Title of Change:	Change in carrier tape design for SSOP16 products	
Effective date:	16 March 2018	
Contact information:	Contact your local ON Semiconductor Sales Office or <Kiyoshi.Mita@onsemi.com>, <Hiroaki.Shimizu@onsemi.com>, <Charles.Francia@onsemi.com >	
Type of notification:	This Product Bulletin is for notification purposes only. ON Semiconductor will proceed with implementation of this change upon publication of this Product Bulletin.	
Change category:	<input type="checkbox"/> Wafer Fab Change <input type="checkbox"/> Assembly Change <input type="checkbox"/> Test Change <input checked="" type="checkbox"/> Other <u>Tape and Reel Change</u>	
Change Sub-Category(s):	<input type="checkbox"/> Manufacturing Site Change/Addition <input type="checkbox"/> Material Change <input type="checkbox"/> Datasheet/Product Doc change <input type="checkbox"/> Manufacturing Process Change <input type="checkbox"/> Product specific change <input checked="" type="checkbox"/> Shipping/Packaging/Marking <input type="checkbox"/> Other: _____

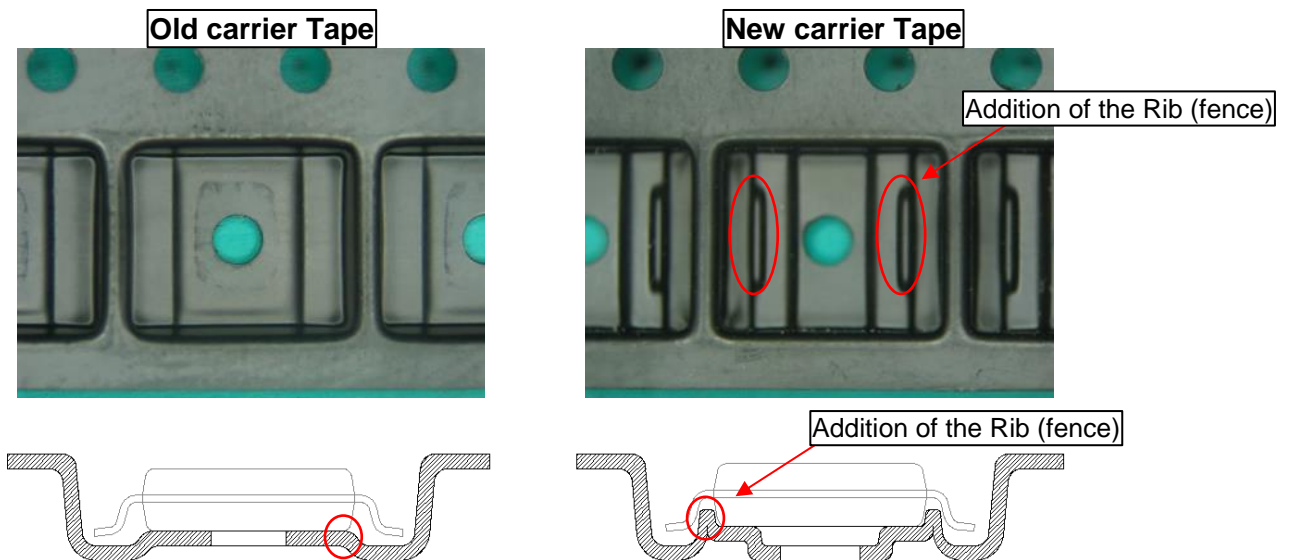
The purpose of the new design is to minimize the movement of the devices inside the pockets of the reel.

Rib (fence) were provided in the pocket to suppress movement of the device.

The device is centered and the new pedestals prevents of the movement of the device.
